**Subject:** Re: 有關A/YL-KTN/1091部門意見回覆

**Proposed Temporary Warehouse (excluding Dangerous Goods Godown) with Ancillary Open Storage and Facilities and Associated Filling of Land for a Period of 3 Years at Lots 1356 (Part), 1359 (Part), 1360 (Part) and 1373 (Part) in D.D. 109, Kam Tin, Yuen Long, New Territories**

(Application No.:A/YL-KTN/1091)

Drainage Proposal - LAYOUT

F.S LAYOUT PLAN

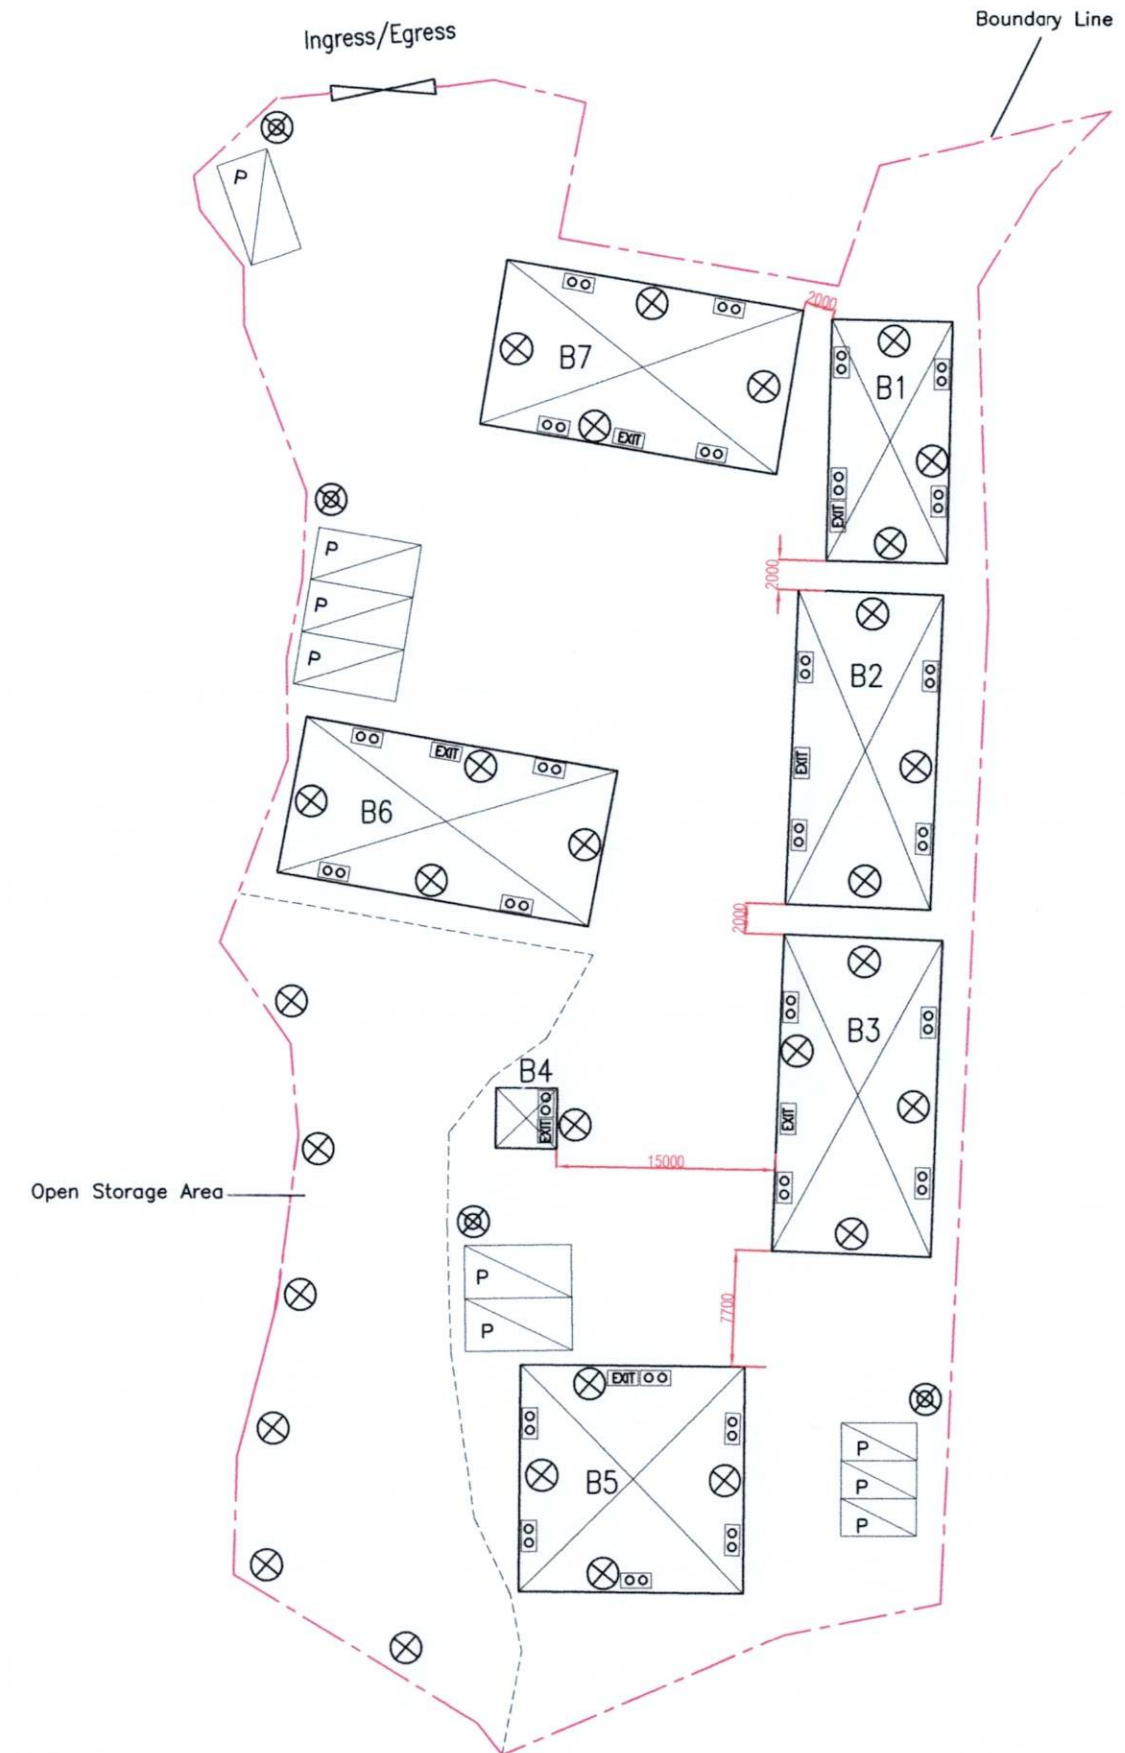
- i. *Sufficient emergency lighting and directional and exit signs shall be clearly marked on plans.*

- Sufficient emergency lighting shall be provided throughout the entire building in accordance with BS 5266-1:2016, BS EN 1838:2013 and FSD Circular Letter no.4/2021.
- Sufficient directional and exit sign shall be provided in accordance with BS 5266-1:2016 and FSD Circular Letter 5/2008.
- Sufficient portable hand-operated approved appliance shall be provided as required by occupancy and as marked on plans.

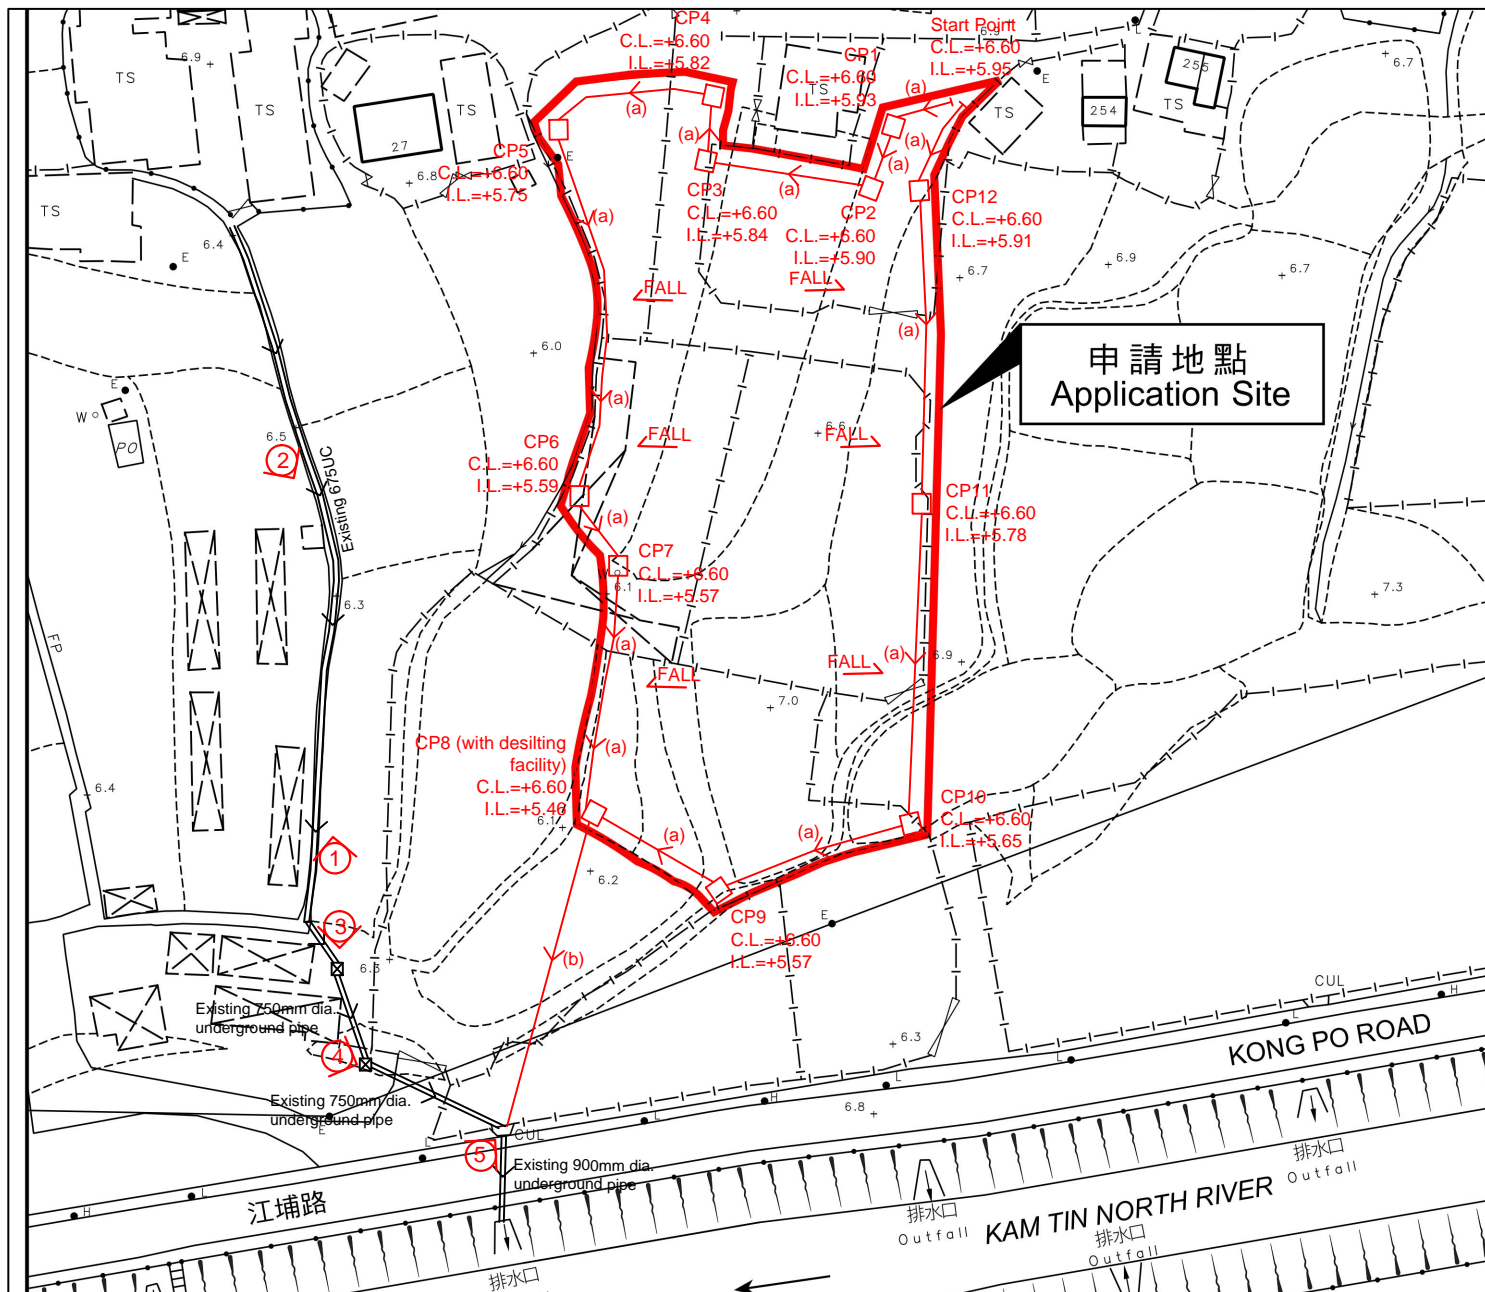
4. Please advise if any site formation/ land filling works to be carried out under this application. Please note that the overland flow from the adjacent lands should not be affected.

5. Cross section – Please ensure the proposed u-channel would be provided at the lower platform (after land filling) matching the existing ground level from adjacent areas.

7. Please provide site photos to show latest condition and existence of the drainage facilities which receive the discharge from the application site. Please justify the dimension by placing a ruler at the u-channel. The site photos should cover whole section of 675UC to final discharge outlet.

9. Please clarify whether any walls or hoarding would be erected along the site boundary. Where walls or hoarding are erected/ laid along the site boundary, adequate opening should be provided to intercept the existing overland flow passing through the site.

**Leveling works will be carried out as shown in the cross sections provided. Such minor leveling works would not affect the overland flow from the adjacent lands.**

**Noted. The proposed u-channel would be provided at the lower platform matching with the existing ground level from adjacent areas.**

**Photos are provided to show the existence of the existing drains at the west of the side (Photo 1-4) and the final discharge point (Photo 5).**

Open-bottom type fence wall to be provided, no overland flow would be affected.

- Catchpits (CP8) with desilting facility shall follow CEDD standard drawing No. C24061.
- Catchpit and UC follows Typical Details of Geotechnical Manual for Slope Fig.8.10 and Fig.8.11 respectively.
- Open-bottom type fence wall to be erected.
- There is no site formation works. Filling works to be carried out to leveling the site.

## Catchment Area for Existing 900mm dia. underground pipe

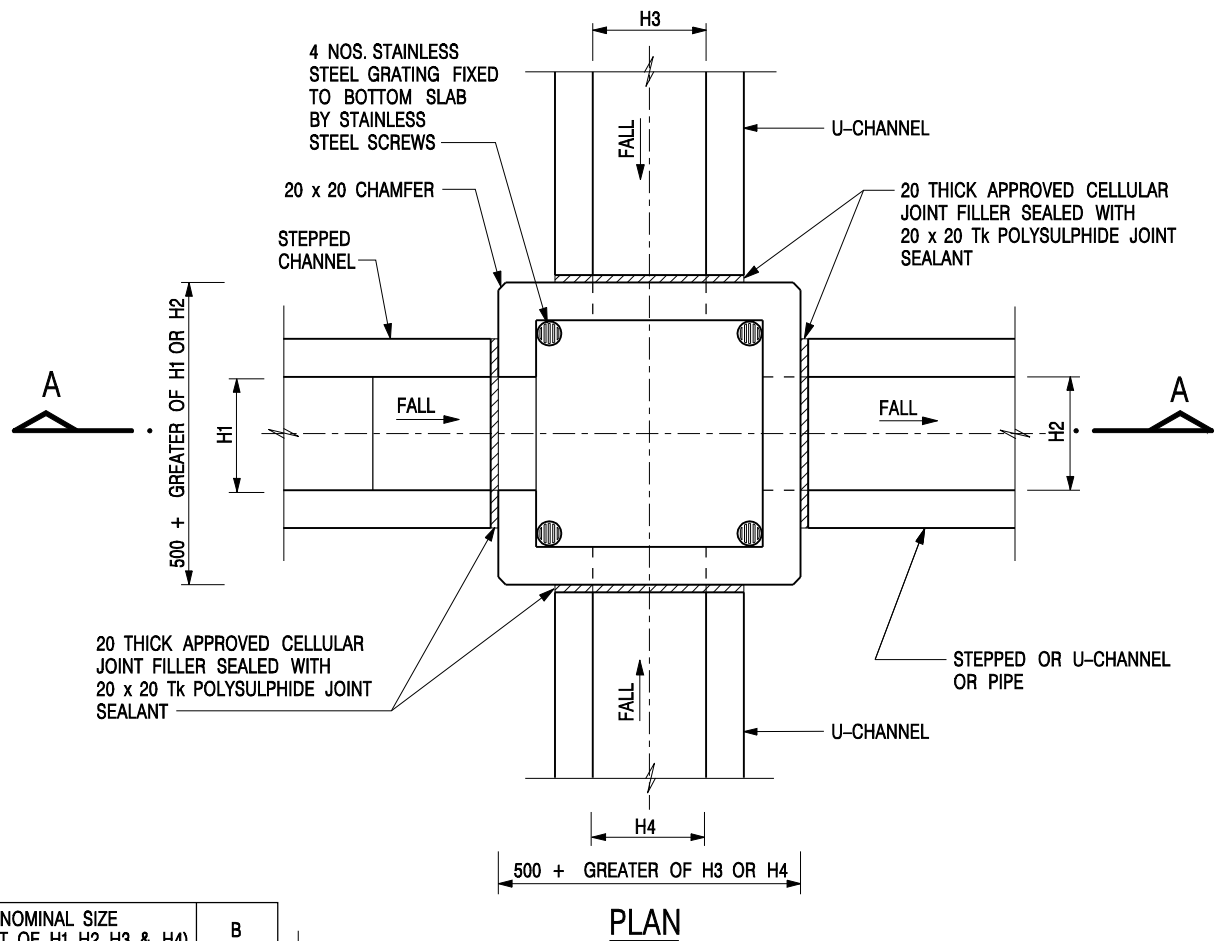
2. Calculation – Please review the second part checking is for 900mm or 600mm dia. pipe.

3. Checking for the existing 675UC should be provided.

**It is reviewed. It should be checking Ex. 900mm dia. pipe.**

**The final discharge point is changed. No discharge to this ex. 675UC.**

For checking Existing 900mm dia. pipe

Provide 900mm dia. concrete pipe (1:100) is OK

Q= 0.8VA (0.8 factor for sedimentation)  
 = 1.287 m<sup>3</sup>/s  
 = 77193 lit/min  
 > 70215 lit/min Ok
